Access Compliance Report

Public Rights-of-Way

Intersection ID: N/A	Main Street: W_W_T_HARRIS_BV	Cross Street: NORTHLAKE_PLAZA_DR	Location: SW
ADA ID: D8C1E27DE645	Ramp Type: BlendTrans1	Initial Pass/Fail: Fail	Overall Compliance: No
		Severity Score: 12.5

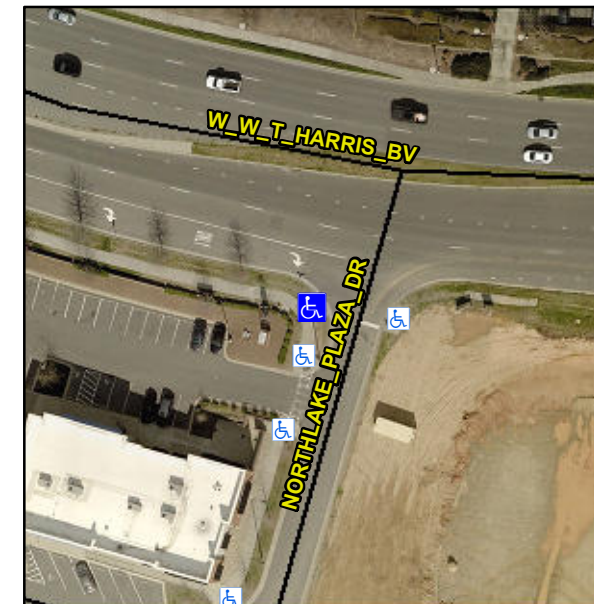
Not Found, R304.5.3

Compliance	Description	Data	Compliance	Description	Data
N/A	Ramp Length (in)	97.0	Yes	BlendTrans Slope (%)	3.9
Yes	Ramp Width (in)	48.0	No	BlendTrans XSlope (%)	5.6
N/A	Flare Type LT	N/A	N/A	Flare Type RT	N/A
N/A	Flare Slope LT (%)	N/A	N/A	Flare Slope RT (%)	N/A
N/A	Flare Traversable LT?	No	N/A	Flare Traversable RT?	No
N/A	Landing Length (in)	N/A	N/A	DWS Provided?	N/A
N/A	Landing Width (in)	N/A	N/A	DWS Contrast?	N/A
N/A	Landing Slope (%)	N/A	N/A	DWS Length (in)	N/A
N/A	Landing X Slope (%)	N/A	N/A	DWS Full Width?	N/A
N/A	Landing Curb? (Y/N)	N/A	N/A	DWS Offset (in)	N/A
N/A	Shared Landing?	N/A			
N/A	Gutter Ponding?	N/A	N/A	Gutter Slope (%)	N/A
N/A	Gutter Lip Ht (in)	N/A	N/A	Gutter X Slope (%)	N/A
N/A	Painted X Walk1?	No	N/A	Painted X Walk2?	No
	X Walk 1 Direction	To E		X Walk 2 Direction	To N
	X Walk 1 Width (in)	N/A		X Walk 2 Width (in)	N/A
	X Walk 1 Slope (%)	1.5		X Walk 2 Slope (%)	1.1
	X Walk 1 X Slope (%)	1.8		X Walk 2 X Slope (%)	1.3

N/A	Ramp inside XWalk1?	N/A	N/A	Ramp inside XWalk2?	N/A
	Road Slope (%)	2.3		Clear Space?	N/A
	Road X Slope (%)	1.2	N/A	Clear Space to XWalk (in)	N/A
N/A	Any Obstructions?	N/A	N/A	Storm Grate/Utility Hazard?	N/A
	Obstruction Type			Storm Grate/Utility Type	
		N/A			N/A
			Yes	Surface Condition? (G/P)	Good
			No	Curb Slope (%)	10.5

Remove & Replace Curb Ramp With Two New Directional Ramps or Equivalent.
